ADDITIONAL DRAINAGE COMMENTS AND PROPOSED WORKS		
ISSUE / ITEM	COMMENTS	ADDITIONAL WORK AND ACTIONS
SA1	IN APRIL 2025 FOUR BREKES (FULLY COMPLIANT) TESTS WERE UNDERTAKEN IN THE OPEN SPACE AREA WHERE THE CURRENT SA1 IS LOCATED. ST1 REPORT 10194 (DATED 22.07.2025). THESE TESTS WERE UNDERTAKEN BELOW THE LEVEL OF THE INSTALLED SA1. THESE TESTS WERE UNDERTAKEN IN THE OPEN SPACE AREA WHERE THE CURRENT SA1 IS LOCATED. ST1 REPORT 10194 (DATED 22.07.2025). THESE TESTS WERE UNDERTAKEN BELOW THE LEVEL OF THE INSTALLED SA1. THESE TESTS WERE UNDERTAKEN IN THE OPEN SPACE AREA WHERE THE CURRENT SA1 IS LOCATED. ST1 REPORT 10194 (DATED 22.07.2025). THESE TESTS WERE UNDERTAKEN BELOW THE LEVEL OF THE INSTALLED SA1.	ENTIRE SA1 (INCLUDING MAINTENANCE MANHOLES AND PERFORATED PIPES) TO BE RECONSTRUCTED BY A NEW 1000mm x 1.2m HAOD. THE AN AREA IS PRESENTED ON THE DRAINAGE DRAWING AND WAS TESTED AS PER DEVELOPMENT TESTS. FROM THE APRIL 2025 TESTS THE WORST INFILTRATION RATE WAS ADOPTED FOR THE CALCULATION OF THE DRAINAGE SA1. APPROVED 2025 TESTS (INCLUDING SHOWN FULLY) FOLLOWING BREKES INFILTRATION AND A LARGE NUMBER OF BREKES TESTING MITIGATED THE UNCERTAINTY OF INFILTRATION POTENTIAL WITH BETTER INFILTRA

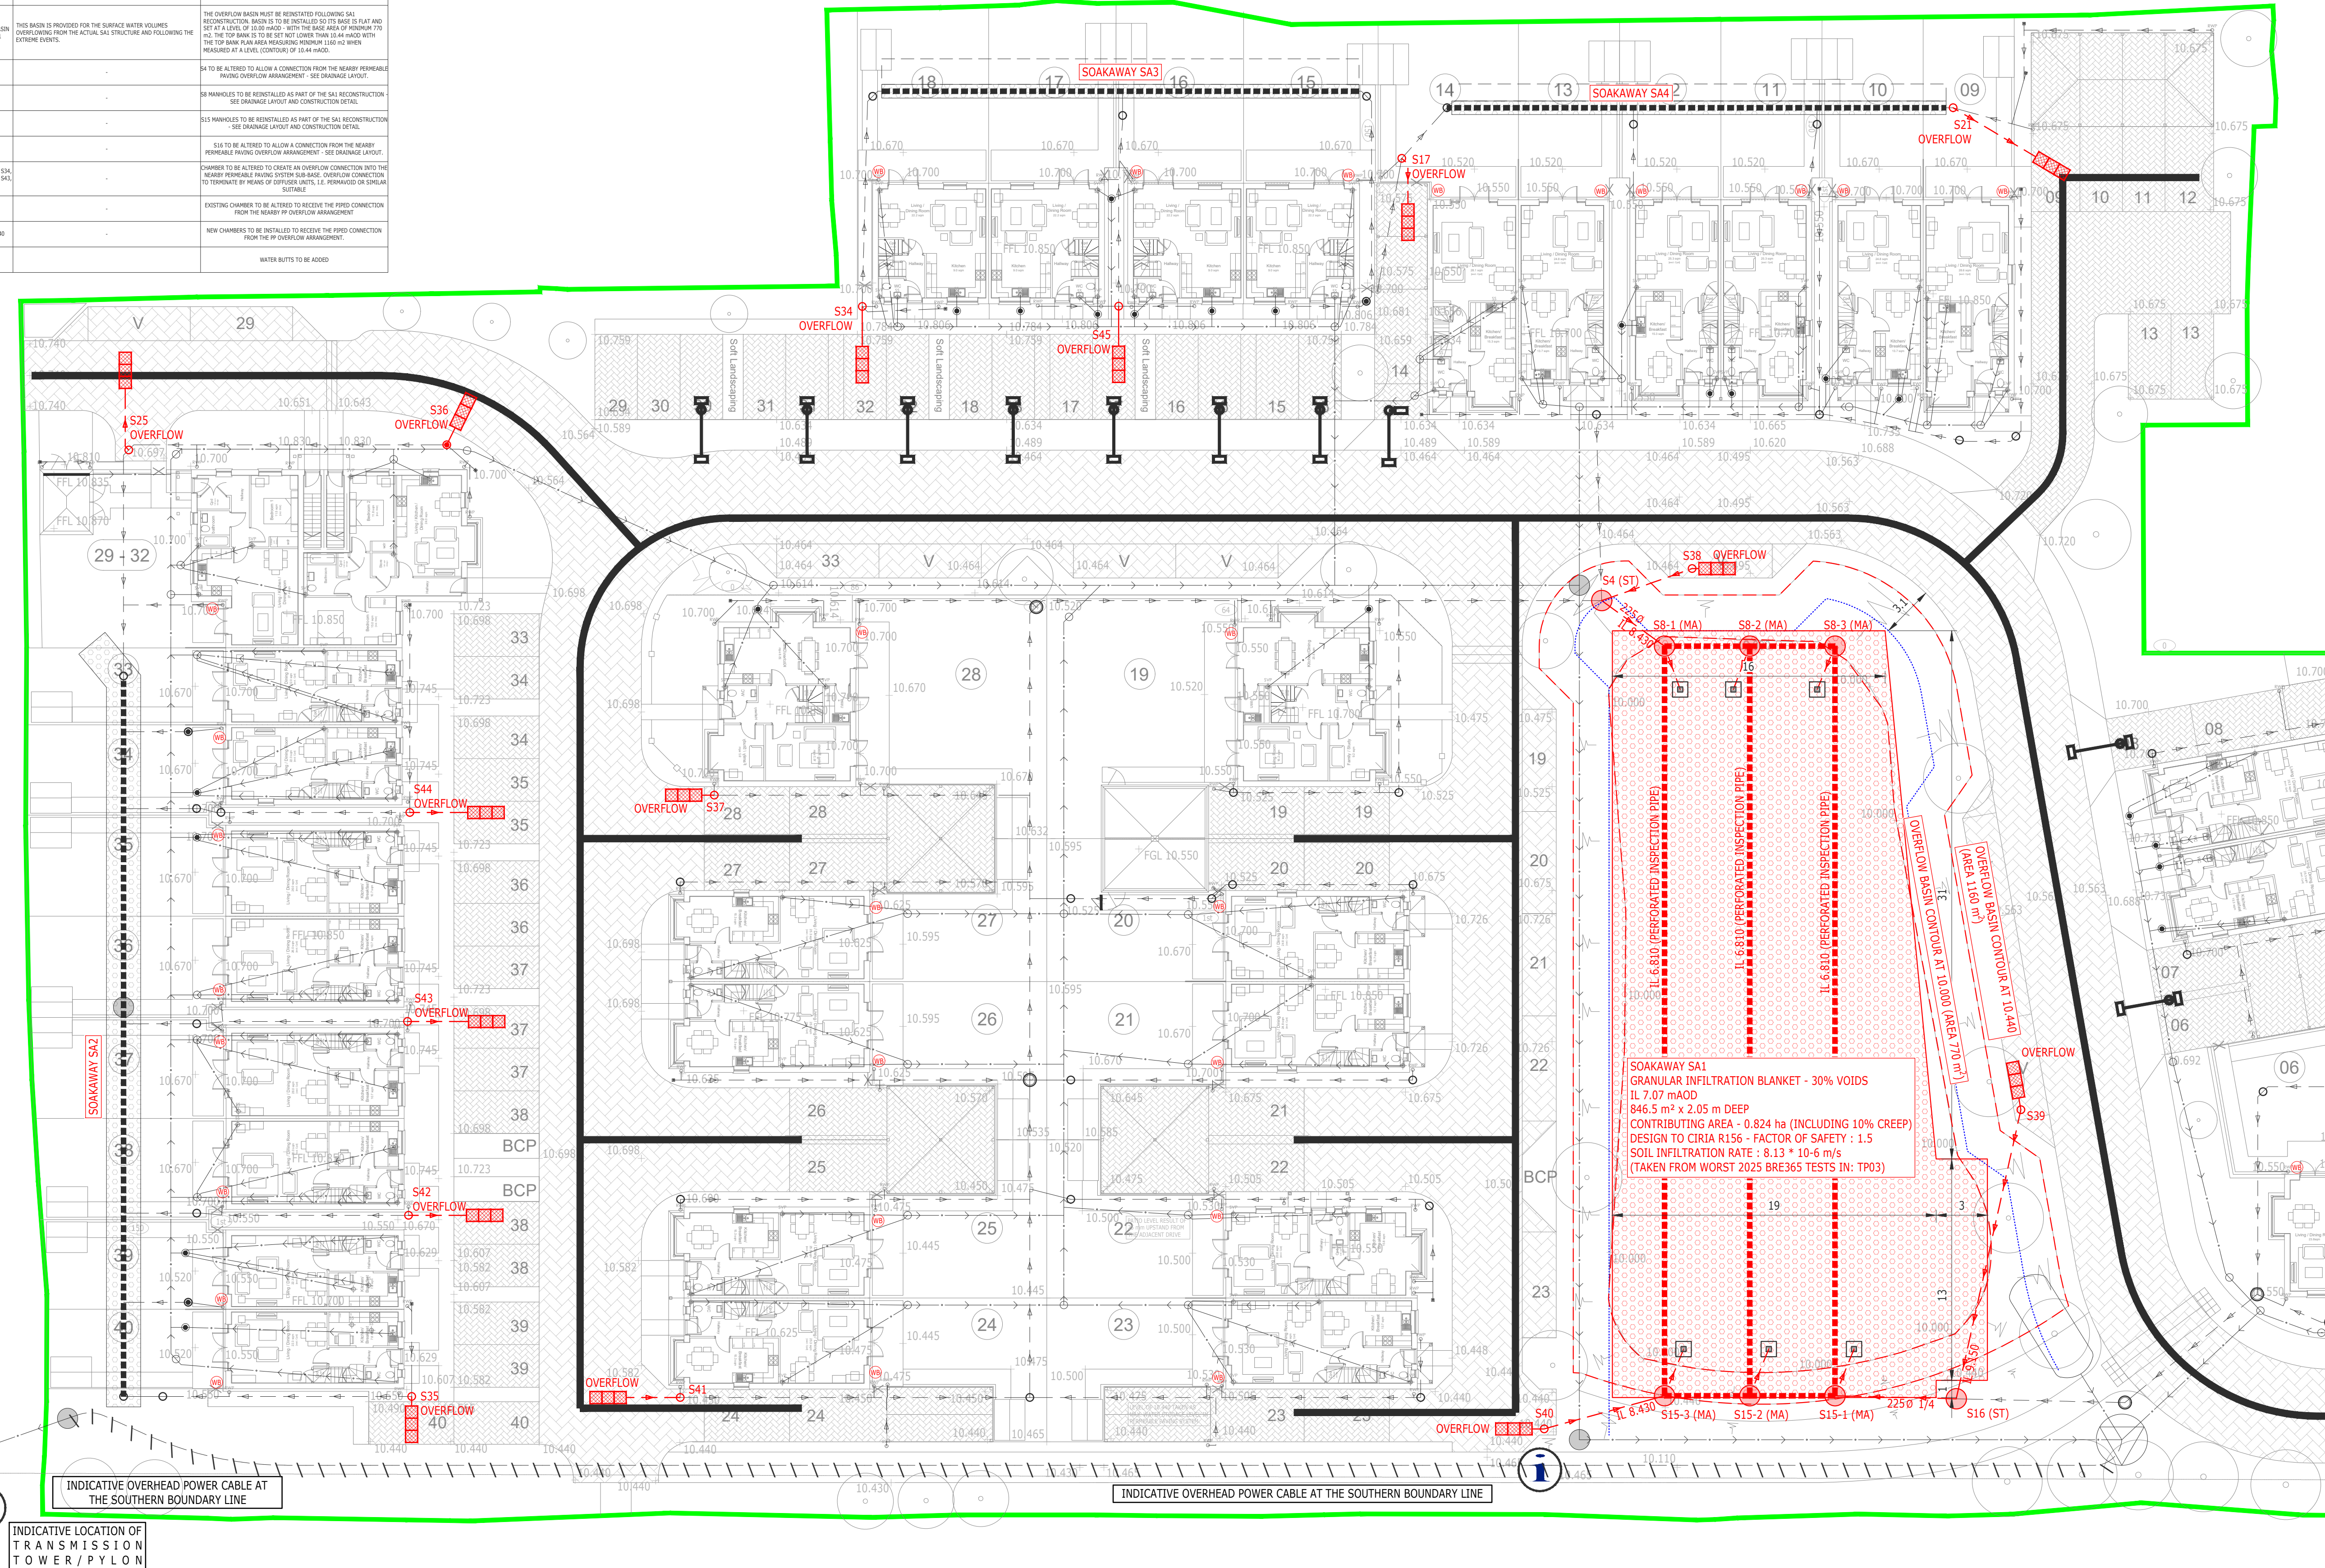
SA2	SA2 STRUCTURE IS TO REMAIN IN-SITU AS INSTALLED. PRE-DEV BREKES TESTING BY LEAP (REPORT LK2368 AND SC20240701) PROVIDED THAT LOCAL AREA AND INFILTRATION POTENTIAL THEREFORE WATER ACCUMULATED WITHIN SA2 WOULD INFILTRATE INTO THE SURROUNDING SOIL WITH TIME. HOWEVER, TO IMPROVE THE OVERALL DRAINAGE SITUATION AND FEASIBILITY FOR THE SITE IT IS PROPOSED TO UNDERTAKE FURTHER ACTIONS.	IGNORING INFILTRATION POTENTIAL OF SA2 IT IS PROPOSED TO INSTALL OVERFLOW FROM THE SW SYSTEM - CURRENTLY CONNECTED TO SA2 - AND OVERFLOW WATER INTO THE PERMEABLE PAVING SYSTEM AND THENCE TO SA1. WITH THIS REVISED DRAINAGE ARRANGEMENT SHOULD SA2 INFILTRATION POTENTIAL AND FILL WATER WOULD BE DIRECTED TO SA1 AND THIS NOT INCREASE FLOODING RISK ON OR OFF SITE.
SA3 AND SA4	SA3 AND SA4 STRUCTURES ARE TO REMAIN IN-SITU AS INSTALLED. SA3 AND SA4 WERE RE-TESTED AS INSTALLED IN APRIL 2025. ST1 REPORT 10194 (DATED 22.07.2025). TESTING PROVIDED THAT LOCAL AREA HAS INFILTRATION POTENTIAL THEREFORE WATER ACCUMULATED WITHIN SA3 AND SA4 WOULD INFILTRATE INTO THE SURROUNDING SOIL WITH TIME. HOWEVER, TO IMPROVE THE OVERALL DRAINAGE SITUATION AND FEASIBILITY FOR THE SITE IT IS PROPOSED TO UNDERTAKE FURTHER ACTIONS.	IGNORING INFILTRATION POTENTIAL OF SA3 AND SA4 IT IS PROPOSED TO INSTALL OVERFLOW FROM THE SW SYSTEM - CURRENTLY CONNECTED TO SA3 OR SA4 - AND OVERFLOW WATER INTO THE PERMEABLE PAVING SYSTEM AND THENCE TO SA1. WITH THIS REVISED DRAINAGE ARRANGEMENT SHOULD SA3 AND SA4 INFILTRATION POTENTIAL WAS TO FILL WATER WOULD BE DIRECTED TO SA1 AND THIS NOT INCREASE FLOODING RISK ON OR OFF SITE.

PERMEABLE PAVING (PP)	PP STRUCTURE IS TO REMAIN IN-SITU AS INSTALLED. PRE-DEV BREKES TESTING BY LEAP (REPORT LK2368 AND SC20240701) PROVIDED THAT LOCAL AREA AND INFILTRATION POTENTIAL THEREFORE WATER ACCUMULATED WITHIN PP WOULD INFILTRATE INTO THE SURROUNDING SOIL WITH TIME. HOWEVER, TO IMPROVE THE OVERALL DRAINAGE SITUATION AND FEASIBILITY FOR THE SITE IT IS PROPOSED TO UNDERTAKE FURTHER ACTIONS.	IGNORING INFILTRATION POTENTIAL OF PP IT IS PROPOSED TO INSTALL OVERFLOW FROM THE SW SYSTEM - CURRENTLY CONNECTED TO SA3 OR SA4 - AND OVERFLOW WATER INTO THE PERMEABLE PAVING SYSTEM AND THENCE TO SA1. WITH THIS REVISED DRAINAGE ARRANGEMENT SHOULD SA3 AND SA4 INFILTRATION POTENTIAL WAS TO FILL WATER WOULD BE DIRECTED TO SA1 AND THIS NOT INCREASE FLOODING RISK ON OR OFF SITE.
OVERFLOW BASIN (OBS)	THIS BASIN IS PROVIDED FOR THE SURFACE WATER VOLUMES OVERFLOWING FROM THE ACTUAL SA1 STRUCTURE AND FOLLOWING THE EXISTING DRAINAGE.	THE OVERFLOW BASIN MUST BE REINSTATED FOLLOWING SA1 RECONSTRUCTION. BASIN IS TO BE INSTALLED TO ITS BASE IS FLAT AND SET AT A LEVEL OF 10.440m WITH THE BASE AREA OF PROPOSED 10.440m. THE TOP BANK IS TO BE SET NOT LOWER THAN 10.44m HAD WITH THE TOP BANK FLAT AREA MEASURING PROPERLY AS WHEN MEASURED AT A LEVEL (CONTOUR) OF 10.44m HAD.

SA1	SA1 TO BE ALTERED TO ALLOW A CONNECTION FROM THE NEARBY PERMEABLE PAVING OVERFLOW ARRANGEMENT - SEE DRAINAGE LAYOUT.	
S18	S18 MANHOLES TO BE REINSTALLED AS PART OF THE SA1 RECONSTRUCTION - SEE DRAINAGE LAYOUT AND CONSTRUCTION DETAIL.	
S15	S15 MANHOLES TO BE REINSTALLED AS PART OF THE SA1 RECONSTRUCTION - SEE DRAINAGE LAYOUT AND CONSTRUCTION DETAIL.	
S16	S16 TO BE ALTERED TO ALLOW A CONNECTION FROM THE NEARBY PERMEABLE PAVING OVERFLOW ARRANGEMENT - SEE DRAINAGE LAYOUT.	
S17, S21, S25, S24, S25, S26, S42, S43, S44, S45	CHAMBER TO BE ALTERED TO CREATE AN OVERFLOW CONNECTION INTO THE NEARBY PERMEABLE PAVING SYSTEM SUB-BASE. OVERFLOW CONNECTION TO TERMINATE BY MEANS OF DIFFUSER UNITS, I.E. PERMAVOID OR SIMILAR SUITABLE.	
S37, S41	EXISTING CHAMBER TO BE ALTERED TO RECEIVE THE PIPED CONNECTION FROM THE NEARBY PP OVERFLOW ARRANGEMENT.	
S38, S39, S40	NEW CHAMBERS TO BE INSTALLED TO RECEIVE THE PIPED CONNECTION FROM THE PP OVERFLOW ARRANGEMENT.

WB	WATER BUTTS TO BE ADDED
